REPORT OF THE PLANNING AND DEVELOPMENT DEPARTMENT FOR

APPLICATION FOR REZONING ORDINANCE 2015-773 TO

DECEMBER 3, 2015

Subject: **Village Square Parcel A - IKEA PUD
R-2015-0773 aka R-2002-0614**

- 0** 11'-6" X 50'-0" INTERNALLY ILLUMINATED CABINET (QUANTITY = 3) 575 SQ. FT. EA.
 - FACES- 3M FLEXIBLE SUBSTRATE WITH 3M VINYL 3630-125 (GOLDEN YELLOW)
 - COPY, 3M VINYL 3630-137 EUROPEAN BLUE BACKGROUND.
 - ILLUMINATION- HOLOPHANE LAMP FIXTURES (20 PER CABINET).
 - 277 VOLT/35.2 AMPS PER CABINET

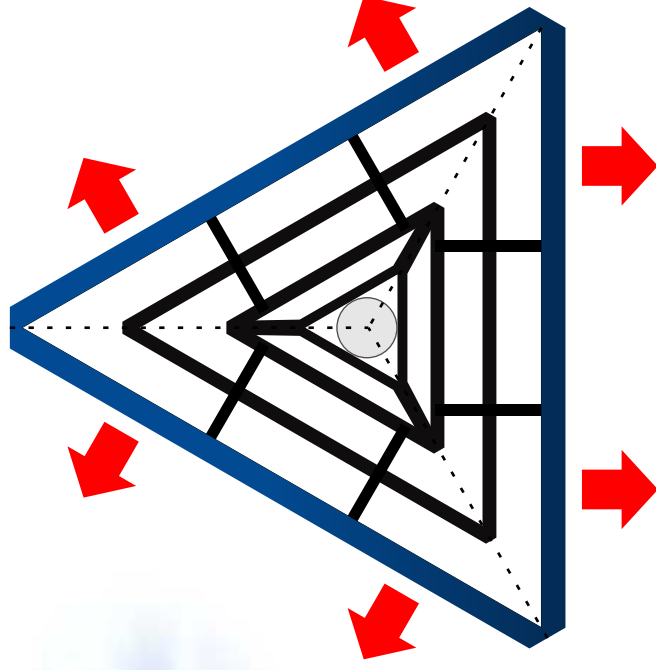
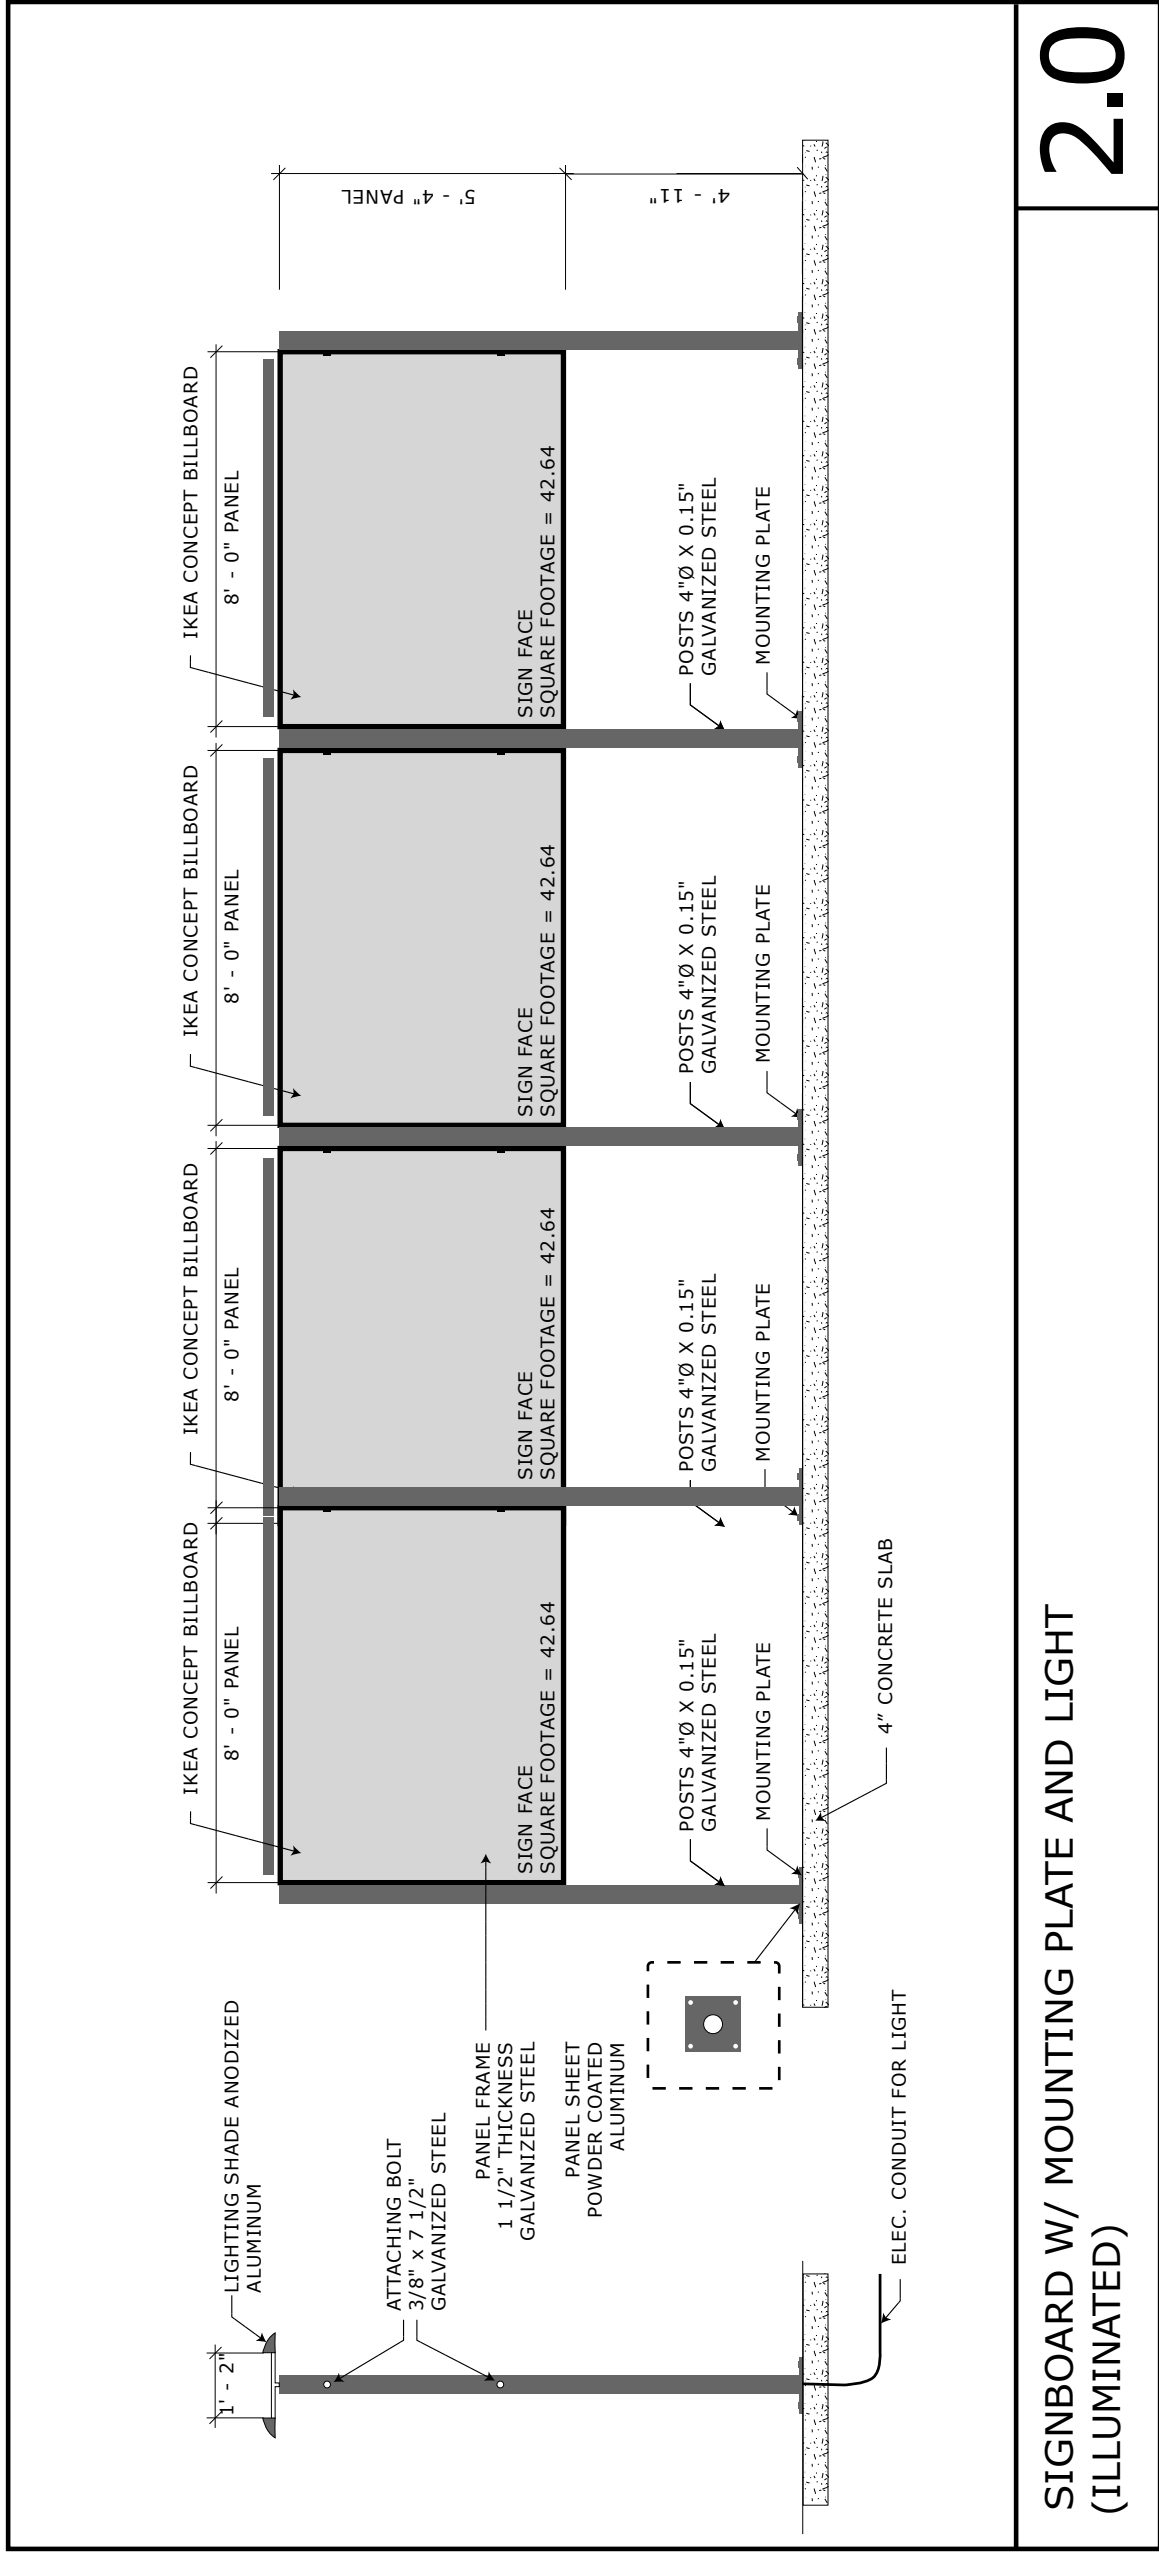
The first is the request for a three sided sign with each panel 575 square feet in area and 108 feet in height. The largest sign allowed by the Zoning Code is 300 square feet, if there is at least 300 linear feet of road frontage. There is approximately 900 linear feet of frontage along I-295, but there is no justification for the 191% square footage increase over what is allowed in the Zoning Code. There is also a request for a maximum sign height of 108 feet. The Zoning Code sets the maximum sign height at 50 feet, unless the sign is within 660 feet of the centerline of an interstate highway exit and then the maximum height is 65 feet. **Staff recommends the maximum sign area of 300 square feet per sign face and 65 feet in height. Approval of the larger signs would set a precedent for future developments to apply for a PUD to allow for a larger sign.**

2. The Interstate sign shall not exceed 300 square feet in area per sign face and 65 feet in height. Wall signs and seasonal banners shall not exceed 10% of the area of a building facade a public right of way. Wall signs and seasonal banners may be internally or externally illuminated.

POLE & FLAG ELEVATION

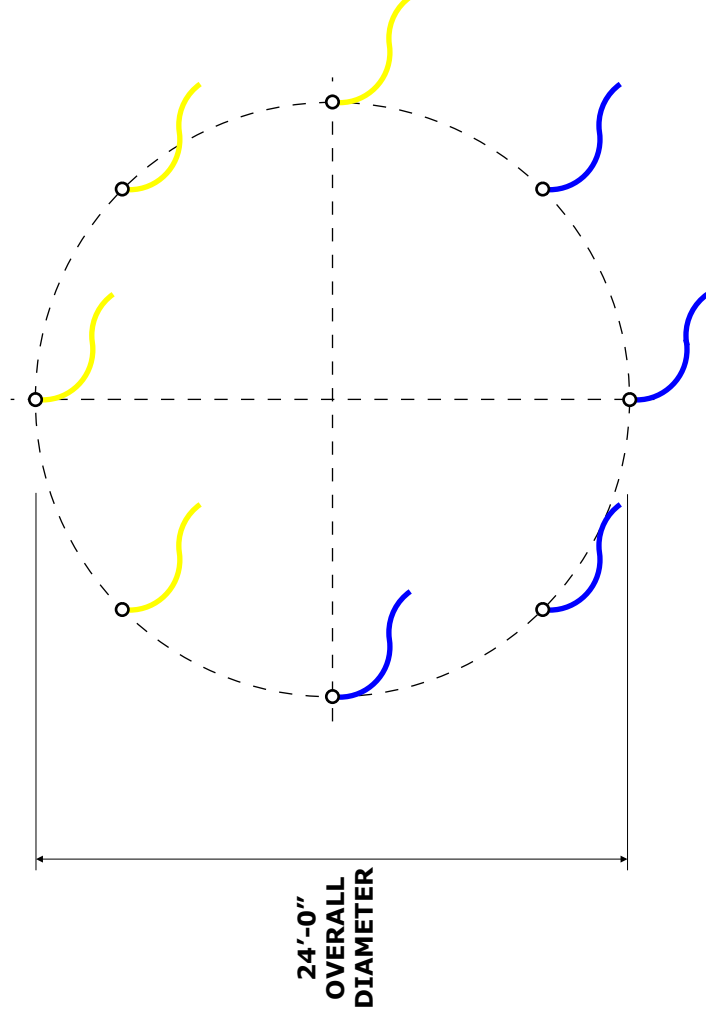
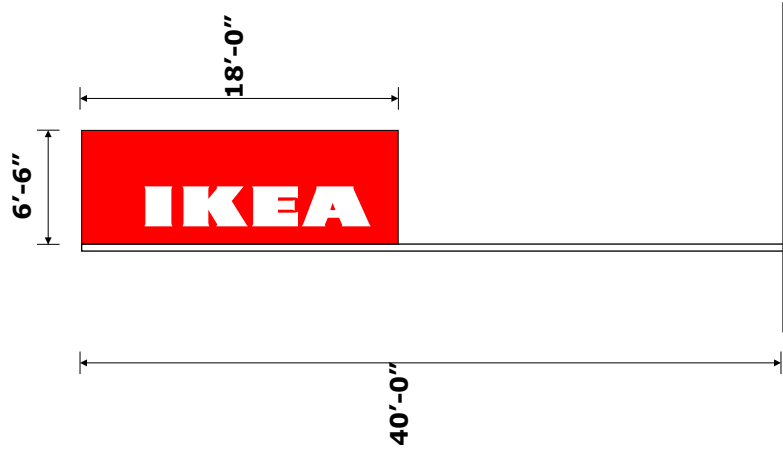
A fifth request is to allow up to 24 flags with each flag 120 square feet in area, 2,880 square feet total. The flagpoles would be a maximum 40 square feet in height. The Zoning Code allows one flag not to exceed 100 square feet in area in lieu of the freestanding ground sign. See photo below at similar IKEA Store. **Staff is of the opinion the flags are excessive, unjustifiable and recommends that one flag, 100 square feet in area be allowed. Staff has concerns about the several requests to substantially exceed the maximum allowances of the sign code and the possibility of future developments using this PUD as a precedent for larger signs.**

3. One IKEA flag not to exceed 100 square feet in area shall be permitted.
4. Interior signs shall not exceed eight (8) feet in height.
5. The property shall comply with Sections 656.1214 (c)(2), 656.1214 (d) and 656.1215 (a)(3), (4) and (5), Zoning Code.
